Atlas Renewables Kirkland 1 and Kirkland 2 Solar Farm Project  
Summary of key project effects  
November 7, 2022

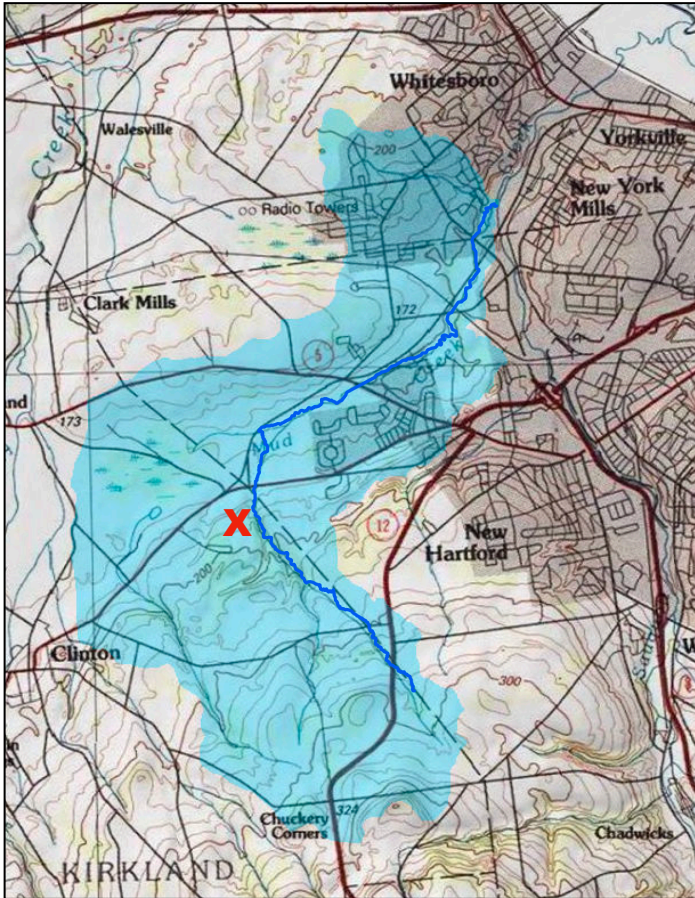
This project will negatively affect wildlife species and diversity onsite and in adjacent habitat. The project plans make no effort to accommodate wildlife or mitigate impacts. In addition to habitat loss due to removing forest and buffers, project fencing will disrupt or block wildlife travel corridors (commonly along streams and wetlands), cutting species off from food and water sources. Species such as deer are more likely to move into nearby residential areas and onto roads. Changes in wildlife distribution and movement will also affect nearby recreation and trail experiences. The proposed 6 inch gap at the bottom of the fence will benefit few species and is not adequate to address these issues. Alternative fencing placement and fence design based on site specific wildlife information can mitigate some of these impacts. This project does not include such measures.

Map 1: Mud Creek Watershed  
X indicates project site location

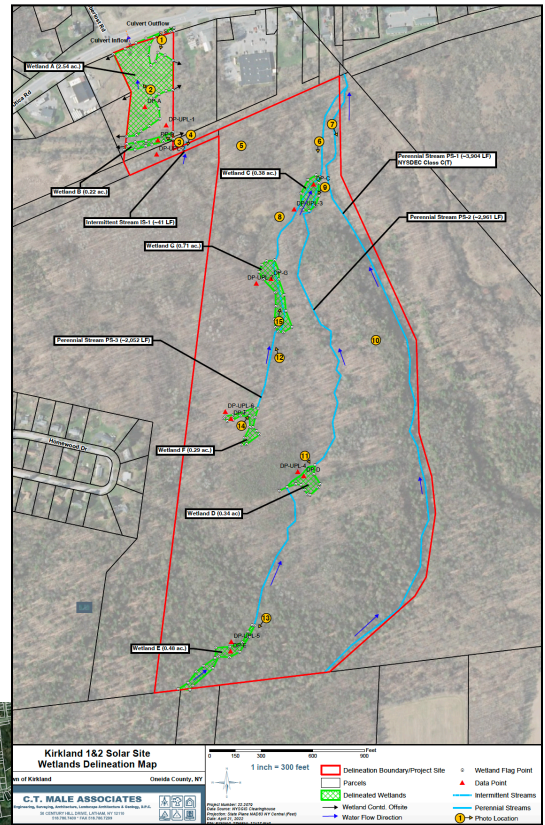
Local projects are proposed and presented for town review one site at a time. However, natural resources — especially water—are connected across many sites, which is why we also need to evaluate each project’s cumulative effects over a larger area. What we do on land affects water supply, flooding, and water quality. Each project that adds its impacts to Mud Creek for example, increases the effects on the overall water system (including the larger Sauquoit Creek watershed to which Mud Creek is a tributary). Upstream impacts affect downstream areas. Land use activities change water systems and the way they work. Whether or not these changes are harmful depends on location, the type and degree of change, and the cumulative effects from multiple projects throughout the watershed.

Mud Creek’s watershed is about 40% forested cover (USGS Streamstats). Cumulative loss of forested acreage in the Mud Creek watershed contributes to increased stormwater runoff, flooding, and erosion. The Trust for Public Land and the American Water Works Association found that the more forest cover in a watershed, the lower the cost for producing clean drinking water.

Map 3: Location of project site within larger forested area

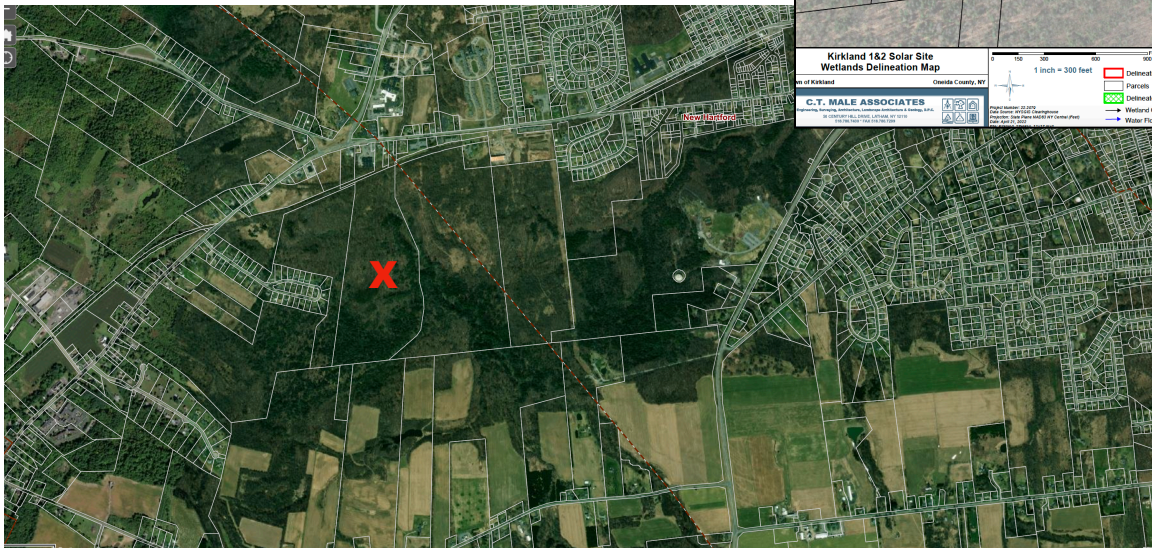
The project site lies within a 500+ acre forested area adjacent to Sherrill Brook Park. This project requires clearcutting 60 acres of forest, significantly fragmenting the surrounding forested habitat (Map 3). Tree removal de-stabilizes soil, decreases groundwater replenishment, increases stormwater runoff and erosion, decreases water quality, and removes habitat. It also decreases capacity for carbon sequestration—the capturing and storing of atmospheric carbon. Sequestration contributes to reducing the impacts of global warming.
